Final Environmental Impact Report

Chapter 7 – Response to Comments

ROSAMOND SOUTH SOLAR PROJECT

Re: Response to Comments for Draft Environmental Impact Report – Rosamond South Solar Project by Golden Fields Solar IV, LLC (PP19151) (SCH#2021060079)

FIGURE 3-8b: CUP Area 2 and 3 Proposed Zoning

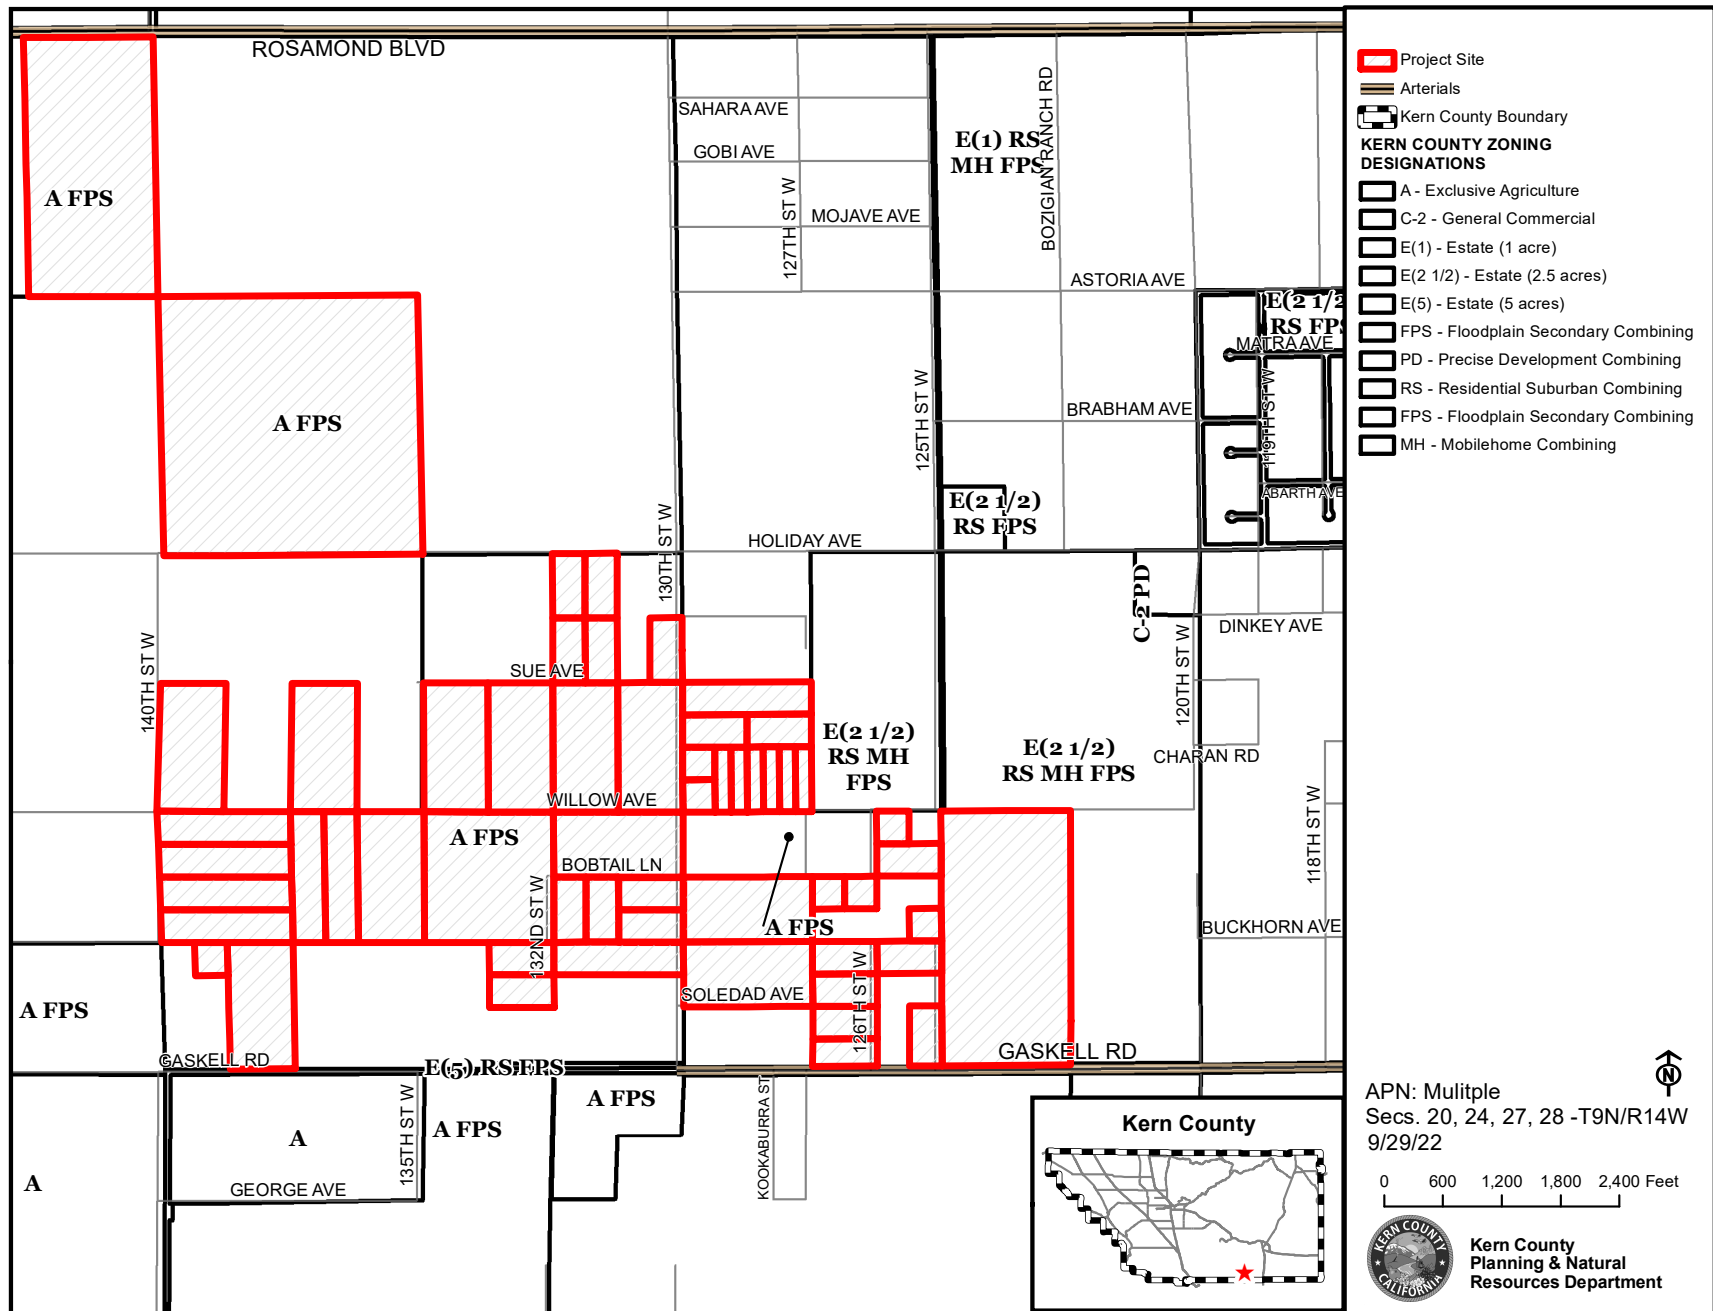
To incorporate two parcels (5-acres each, for a total of 10 additional acres) within the project area that were acquired since circulation of the Draft EIR:

- Total project area is on an approximate 1,292 ~~1,302~~-acre site.
- Number of parcels with project area is ~~64~~ 66 parcels.
- CUP Area 3 (Conditional Use Permit No. 46, Map No. 232) is ~~541.16~~ 551.16 acres.
- Zone Change Case No. 43, Map No. 232 from the existing zone district E(5) RS FPS to A FPS on approximately ~~330~~ 340 acres and from existing zone district E(2 ½) RS FPS to A FPS on approximately 96 acres
- The figures for CUP Area 3 are revised to include the two parcels within the project area as shown in the following **Figure 3-4b: CUP Area 2 and 3 Existing Willow Springs Specific Plan Designations** and **Figure 3-8b: CUP Area 2 and 3 Proposed Zoning**.
